## Product Change Notification / SYST-18SFAM011

ERRATA - AVR128DA28/32/48/64 Silicon Errata and Data Sheet Clarification

## Silicon Errata and Data Sheet Clarification

### 2.5.1 Flash Mapping Into Data Space not Working Properly

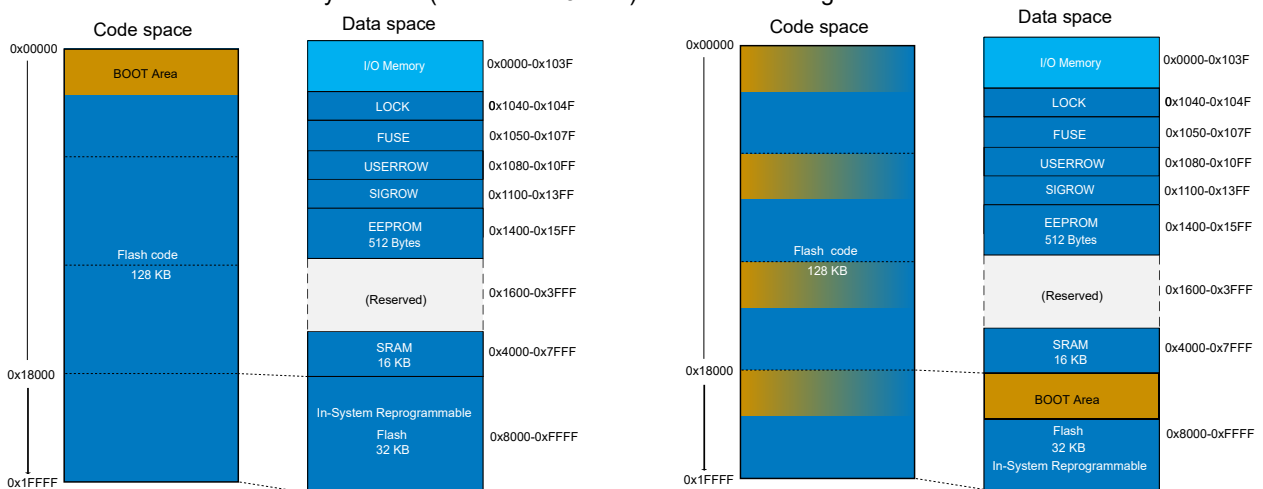
The inter-section Flash protection mechanism does not take into account the FLMAP bit field when checking if the address is in BOOT, APPCODE or APPDATA areas. It uses for comparison only the address offset between Flash start address in data space (0x8000) and the accessed address. This will cause the mirroring of the BOOT area in each Flash section selected by FLMAP (in blocks of 32 KB). Refer to the image below.

BOOT area for devices without issue

BOOT area for devices with issue

For read operations, the FLMAP bits work as documented when the Boot Read Protect (BOOTRP) bit is not enabled. For write operations, the inter-section Flash protection works properly only when FLMAP is set to '0x00'.

Use only store program memory (SPM) instructions to write and load program memory (LPM) instructions to read Flash memory.
